This note affects a specific revision of the iMX6 SoloX COM board (product number: EAC00244). The board is also sold as part of the iMX6 SoloX Developer's Kit (product number: EAK00245).

Note about simultaneous Ethernet #0 and Parallel RGB interface usage

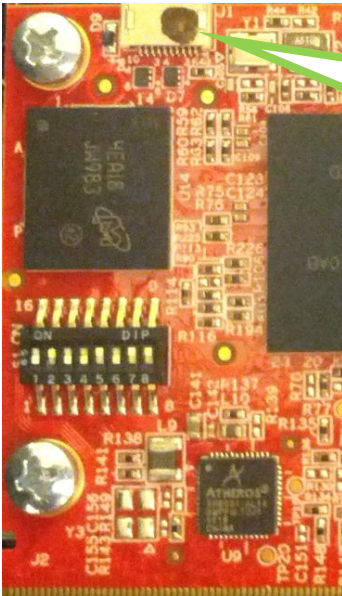
Most affected boards have been reworked. Only a few number of boards have been delivered and these boards need a small rework. The picture below illustrates how to identify if the board has been reworked, or not. If there is a black marking on the debug connector, like shown, the board has already been reworked and no further action is needed.

A black dot on the debug connector indicates that the board has already been reworked and is NOT affected by this note.

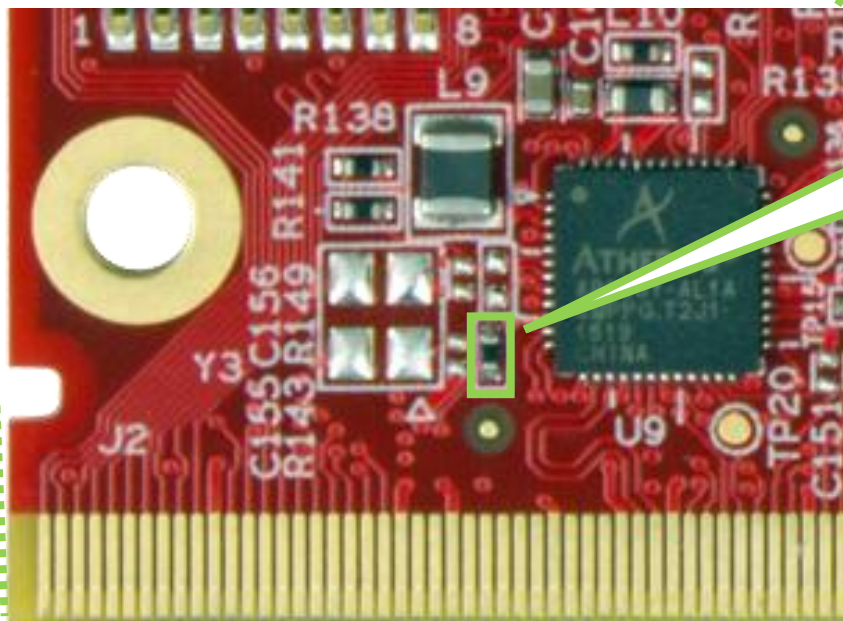
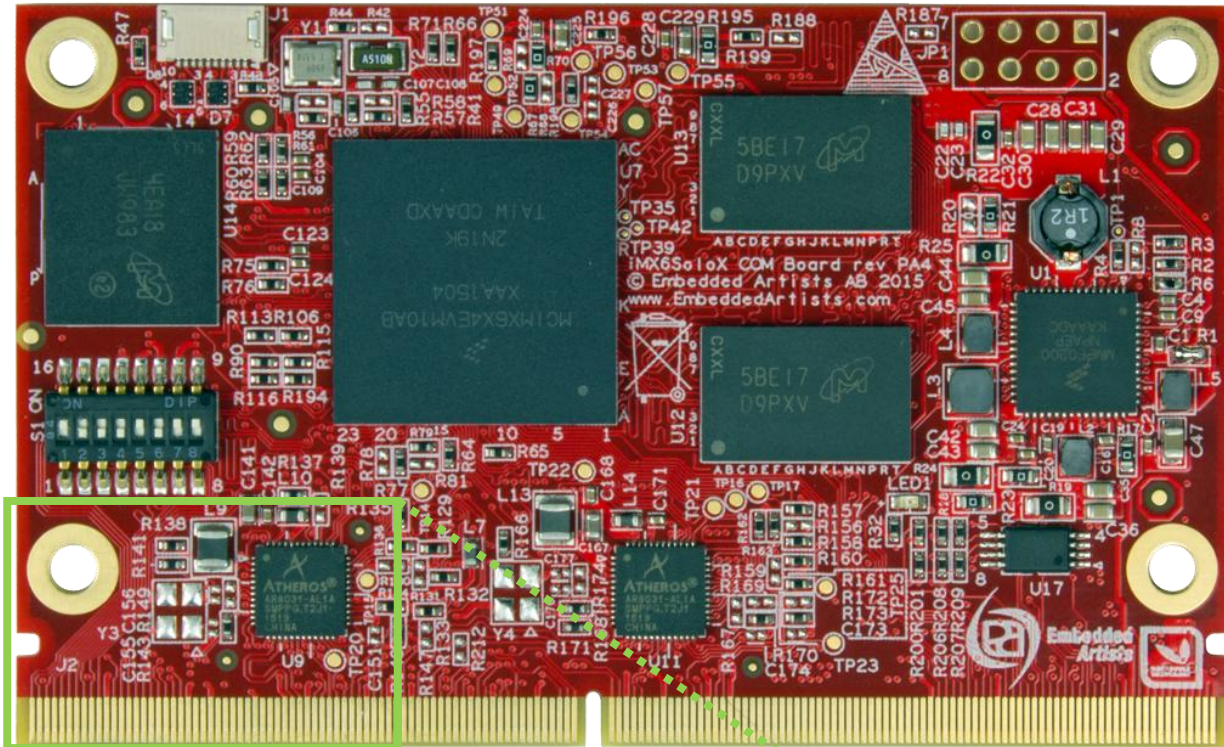
When the parallel RGB interface is active, under some circumstances a reference clock signal to Ethernet interface #0 is affected. This make it impossible to have reliable Ethernet communication on interface #0 (at the same time as the parallel RGB interface is active). The underlying reason is improper impedance matching of the Ethernet reference clock, causing ISI noise.

Replace R143 with a 20, 22 or 30 ohm resistor (0402-size). See pictures below to locate R143.

Replace R143 with
20, 22 or 30 ohm
resistor (0402-size).
